**Re: Indian Cycle Dealership, 4509 Alameda Blvd. NE**  
**Certificate of Occupancy – Transportation Development**  
Administrative Amendments Stamp dated 08-29-14 (C17-D002A22)  
Certification dated 12-02-14

4509  
RE: **Indian Cycle Dealer, 4508 Alameda Blvd. NE**  
**Grading & Drainage Plan For Grading and Paving Permit**  
**Engineer's Stamp Date 4-30-2014 (File: C17D002A22)**

**RE: Indian Cycle Dealer, 4508 Alameda Blvd. NE  
Grading & Drainage Plan For Grading and Paving Permit  
Engineer's Stamp Date 7-14-2014 (File: C17D002A22)**

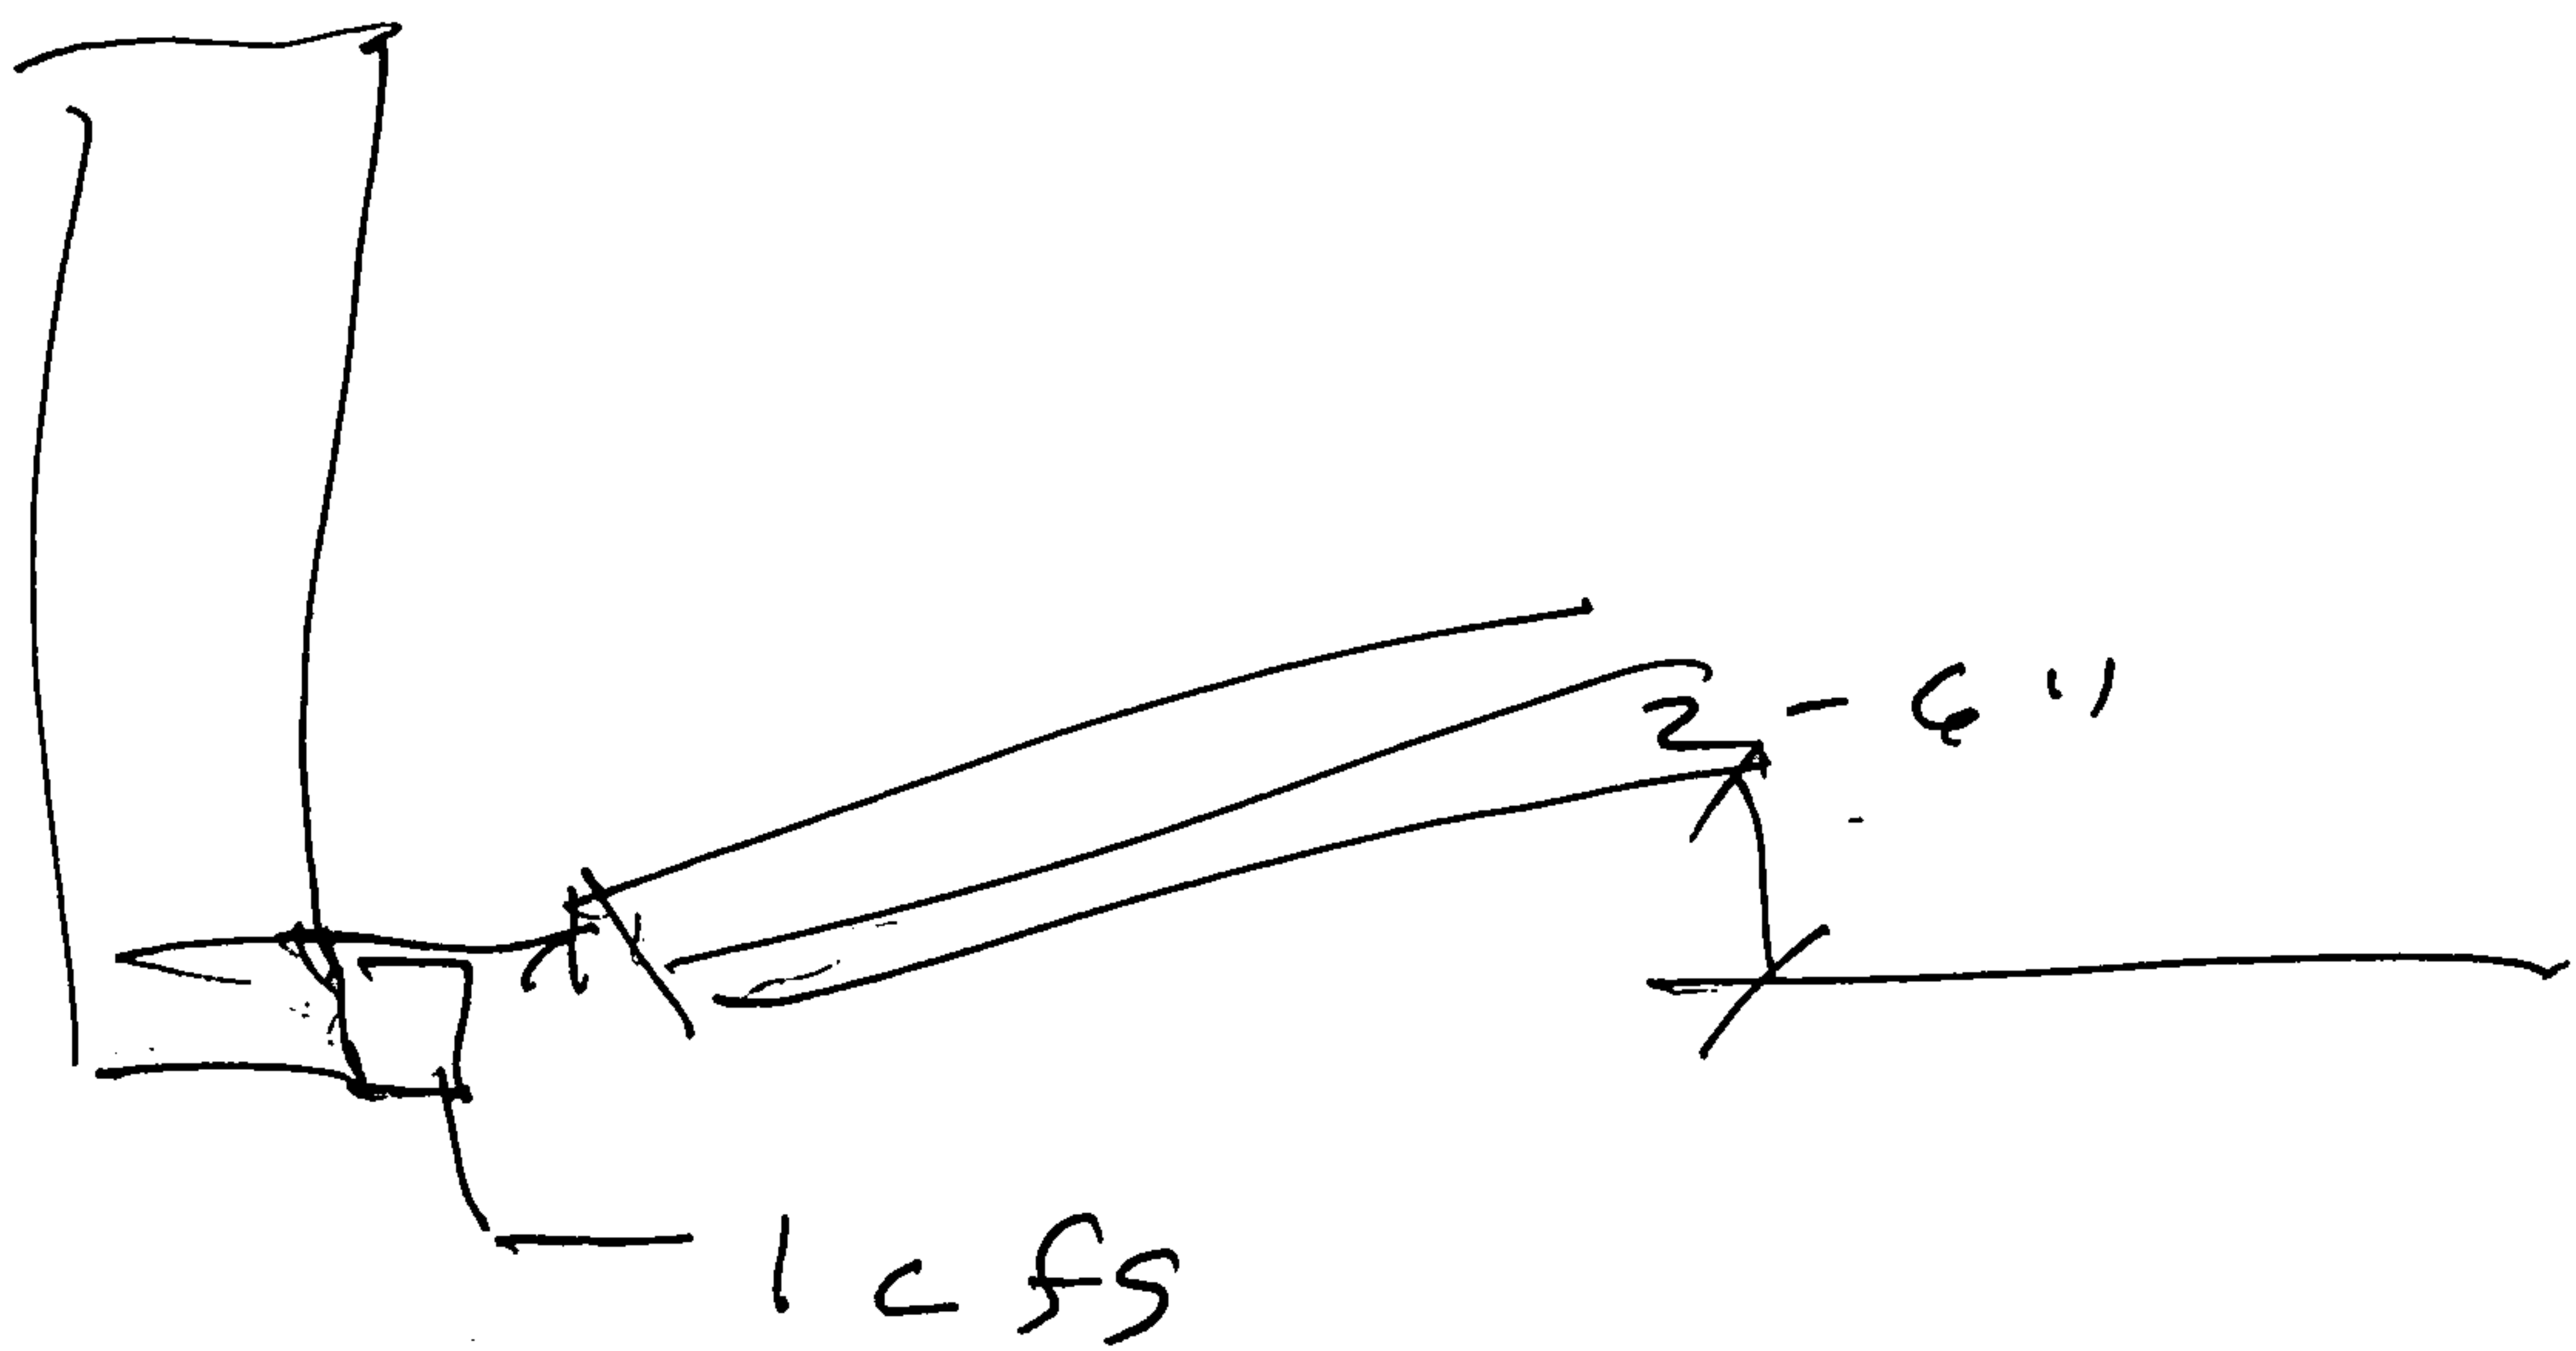
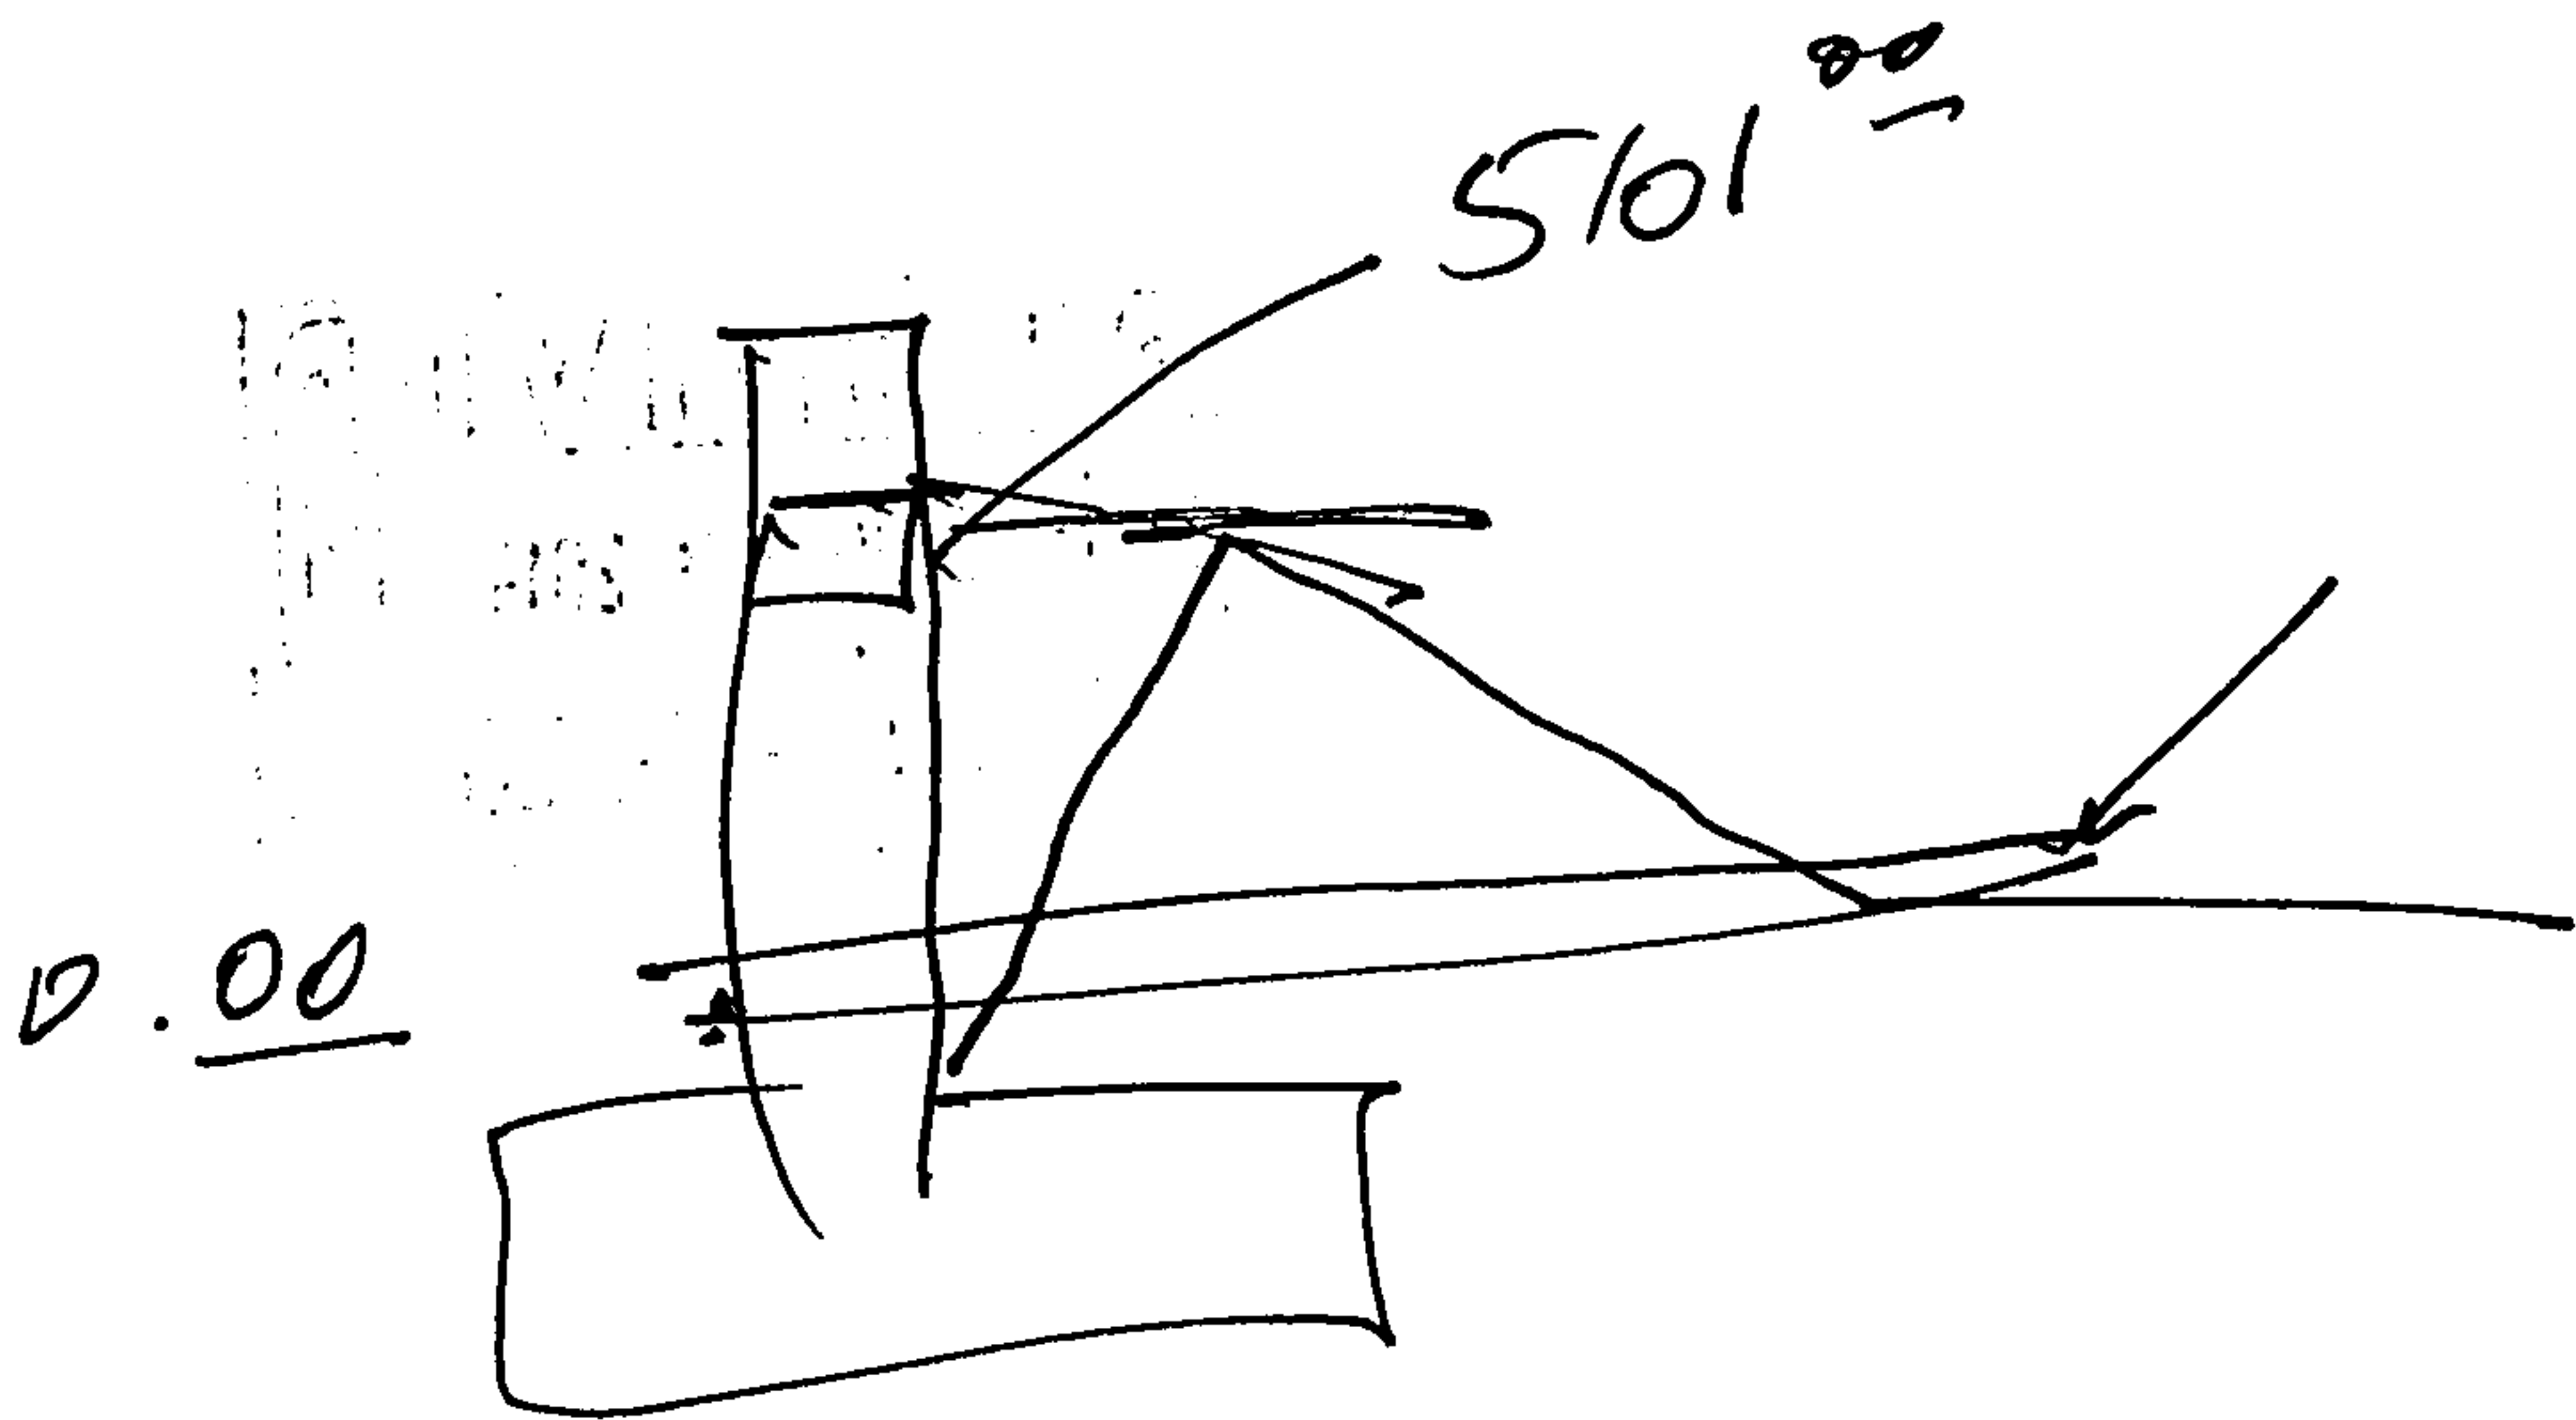
1. The 6 inch pipes are to extend through the CMU wall and the openings around the pipes grouted.
2. The grade of the dirt at the northwest corner of the pond is to be at or above the water surface elevation (01) and two blocks are to be removed from the wall at the 01 or top of dirt elevation for an emergency spillway.
